PLAN AND PROFILE OF NEW HANDICAP RAMP AT STARBUCKS 1080 FOREST AVE. PORTLAND, MAINE.  
APRIL 26, 2007 SCALE AS NOTED  
REVISED MAY 10, 2007: EXPANDED RAMP 52" WIDE AND ADDED HANDRAIL  
DRAWING NO. 2004121rev12-PP

**Re: Site Plan Review: Starbucks Drive Thru, vicinity of 1080 Forest Avenue  
Amendment to Approved Plan re ramp/lighting  
CBL #146 B014001  
Application # 2006-0219b;**

To: Phil DiPierro  
From: Bauman Electric, Inc. 838-0475  
Subject: Starbucks Coffee Co. outdoor lighting (1080 Forest Ave, Portland)  
Date: 5/31/07  
No. of Pages: 7 including cover.

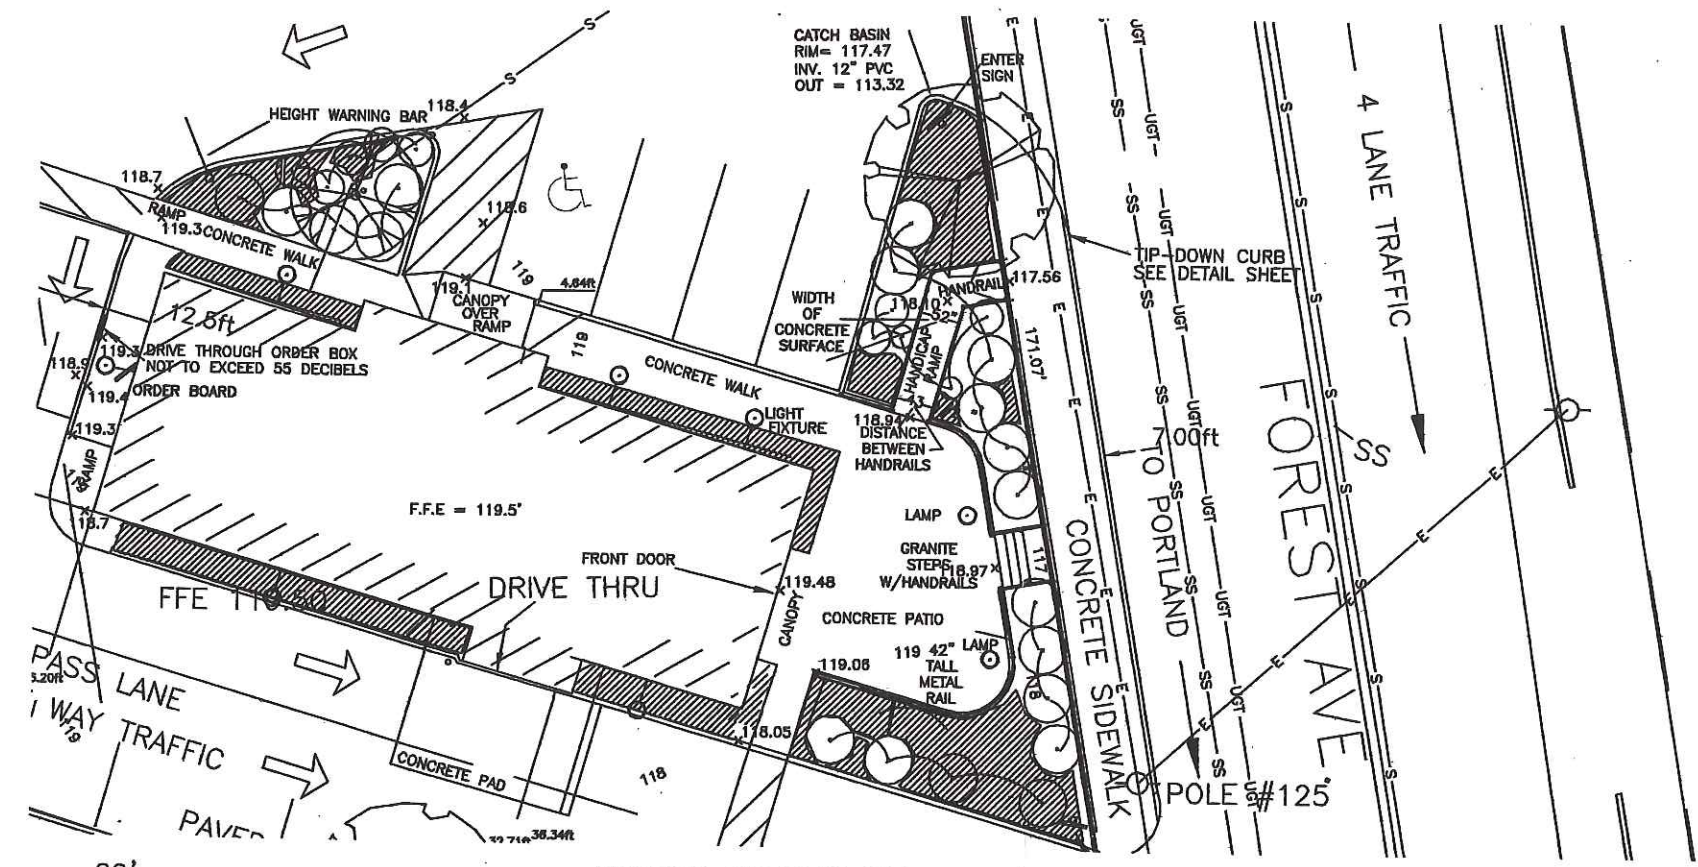
Regarding the ramp access and patio revisions, I confirm that the "as built" now on site meets city requirements and is satisfactory. Could you please submit the final version of the detailed plan of the patio and access ramp so that this may be referenced in the approval letter and placed on the planning file.

This letter is to confirm that the further revisions to the approved site plan for the proposed new single story building for use as a Starbucks Drive Thru, at the above address, have been reviewed and approved. The amendments include the creation of a stepped access and a ramped access (both with handrails) from Forest Avenue and additional and revised lighting fixtures.

The approval is based on the submitted revised Site Plan and Ramp Profile (Drawing No. 2004121rev12-PP Revision dated May 10, 2007), Photometric Lighting Grid Revision 9 (as updated 05-29-07), submitted catalog cuts, and letter from the lighting manufacturer dated June 5, 2007 confirming that the light fixtures comply with full cut off requirements.

The Baselite Model No: SBW11018/XX/PR4 (18" self-ballasted warehouse shade 100W MH Prismatic 4") is Dark Sky Rated. The fixture is designed for the lamp not to protrude from the bottom of the shade for full cut off.

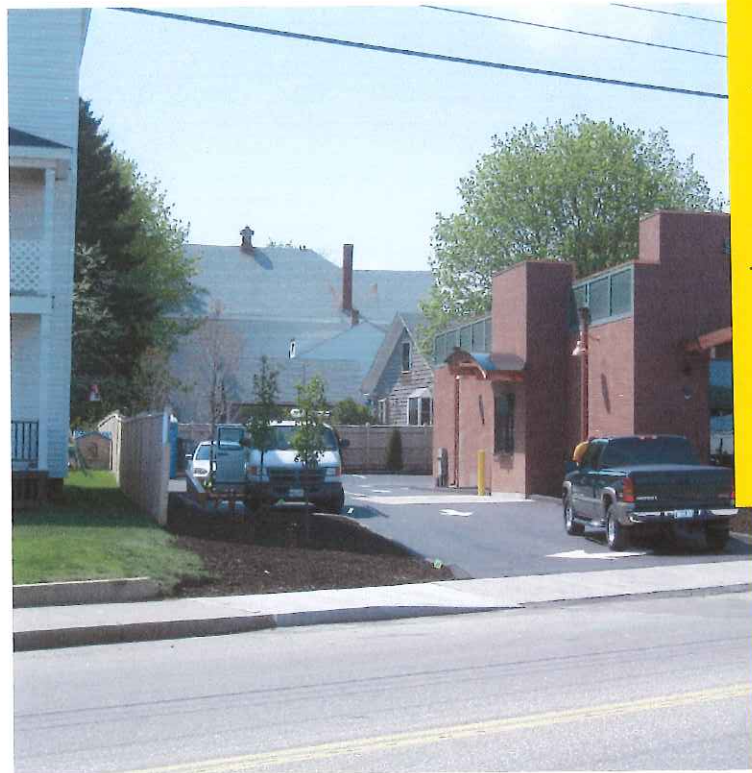
Enclosed please find the letter from Baselite confirming full cut off for the fixtures in question. The "Prismatic 4" refers to the globe portion of the fixture. It has been Dark Sky Rated as a unit. Please call with any other questions. Thank you very much for your help and patience.

ORIGINAL PACKAGE  
APPROVED BY THE CITY OF PORTLAND

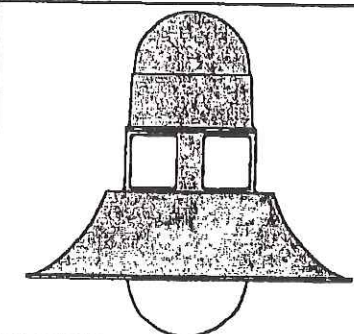
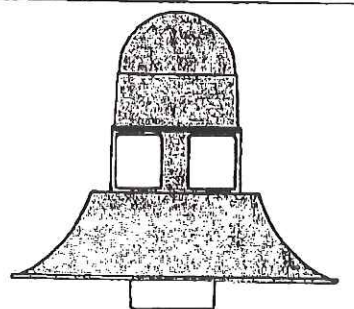
Page 5 is an illustration of the light fixture head originally approved by the City of Portland prior to the start of the project. Notice the globe also extends below the shade and in addition lets more light out through the mid section. We merely went with a different brand, a company we worked with in the past. (Baselite) Please understand we thought we were safe mimicking the original fixture. Time constraints dictated changing brands. Our lights needed to be shipped in an acceptable time frame and Baselite was there for us.
